SUBJECT: Project Review and Development of Preliminary Design of
Hatchery Creek Enhancement Project

HATCHERY CREEK FISHWAY HYDROLOGIC STUDY

HATCHERY CREEK FISH ENHANCEMENT PROJECT

FIG. 1. HATCHERY
CREEK FALLS

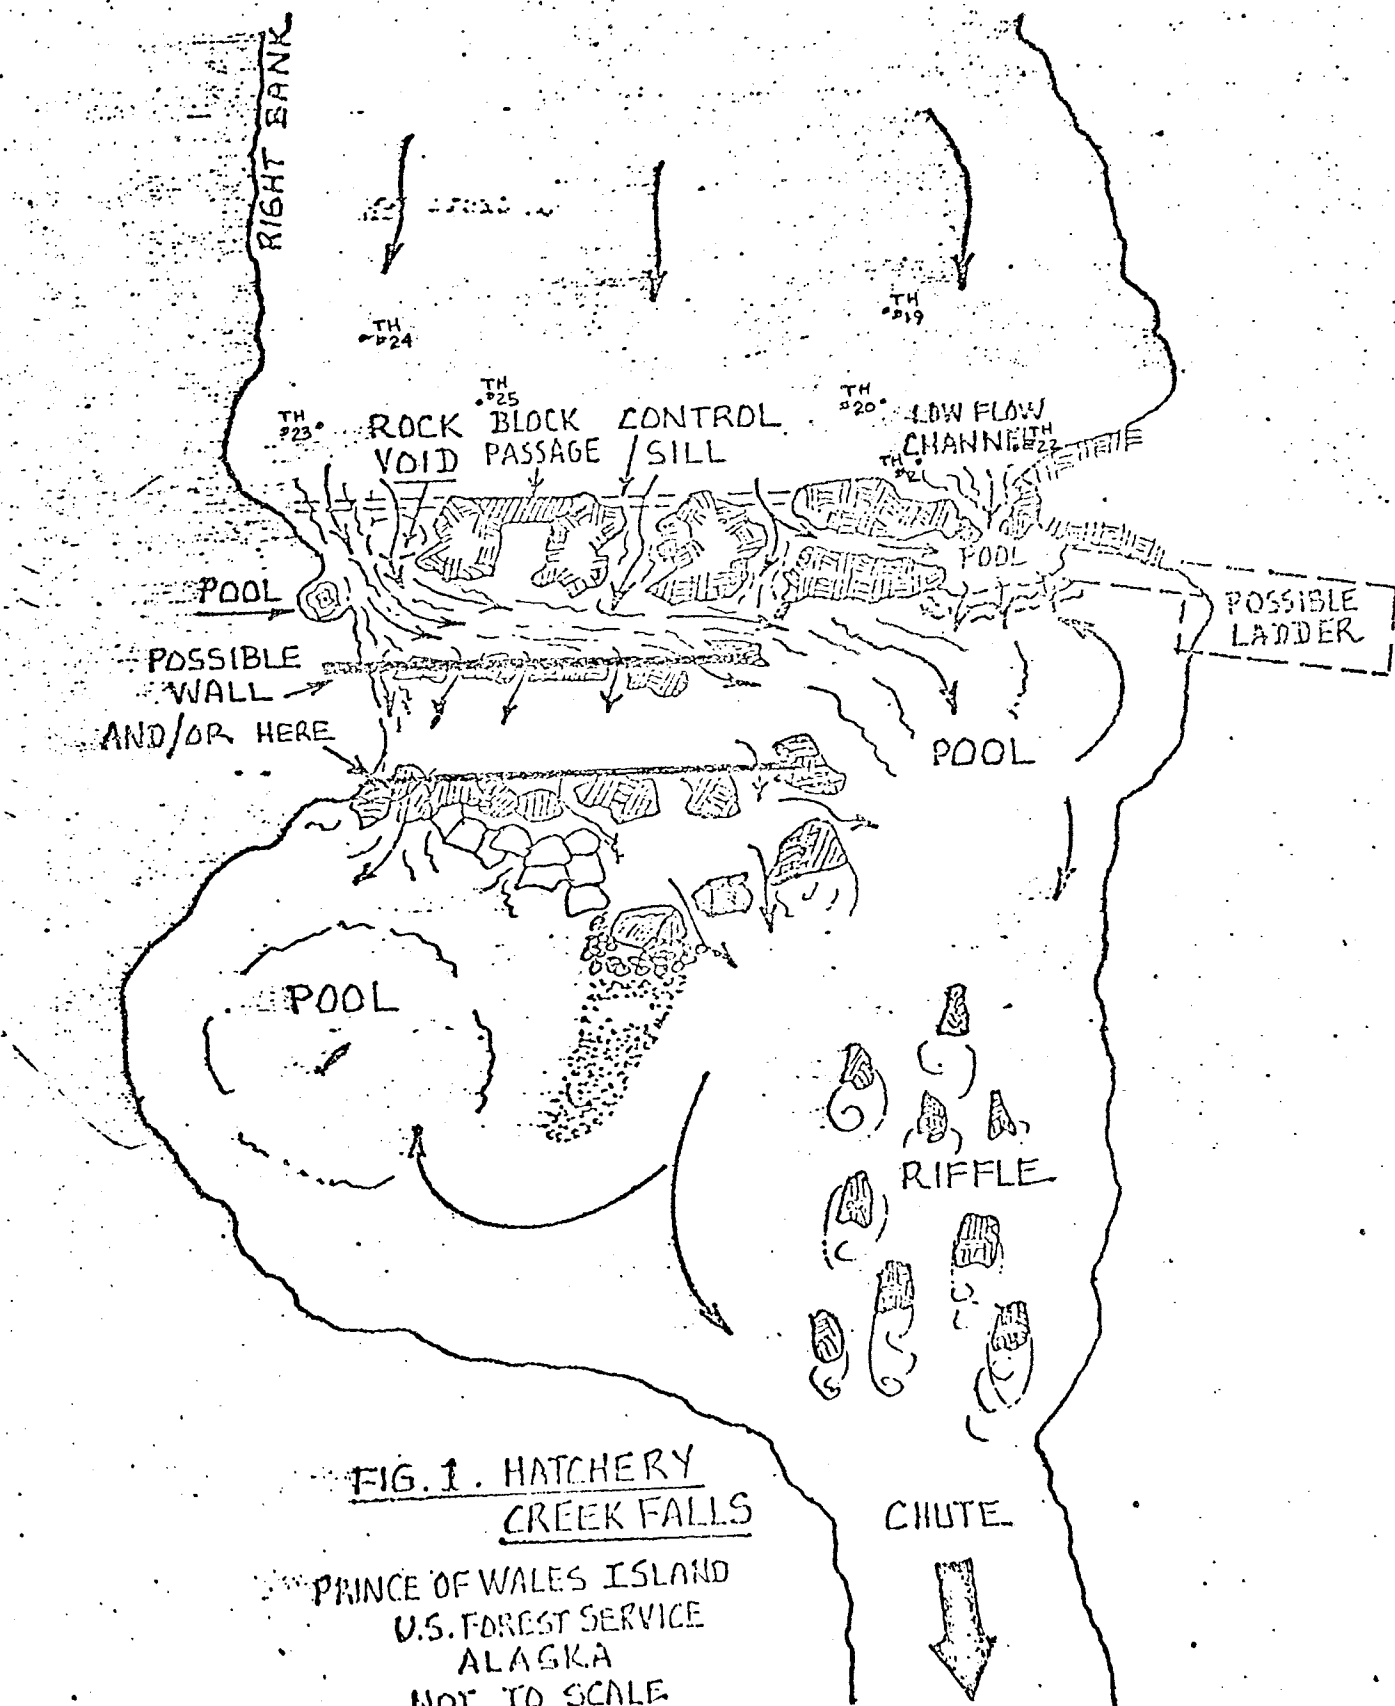
The control sill will be possible to install with some rock grouting and rock bolt anchors but; will be subjected to rough treatment by logs at intermediate and high water flows (Fig. 1).

Rock is available for a foundation base for that portion of the "possible ladder" to be constructed below the falls. This portion of the structure will be protected by the rock outcrop directly upstream. At the fish outlet, it will be possible to modify the adjacent pool and "low flow channel" for the improvement of entrance flow conditions (Fig. 1).

The walls shown below the falls are evidently to enhance the high flow conditions (Fig. 1). These walls may not be stable during intermediate and high flows of logs and ice, and tend to direct the "attractive" current in the wrong direction during low to intermediate flows. These walls, at best, will be difficult to design. There is also the possibility that they may not last through the first ice and log laden high water flow.
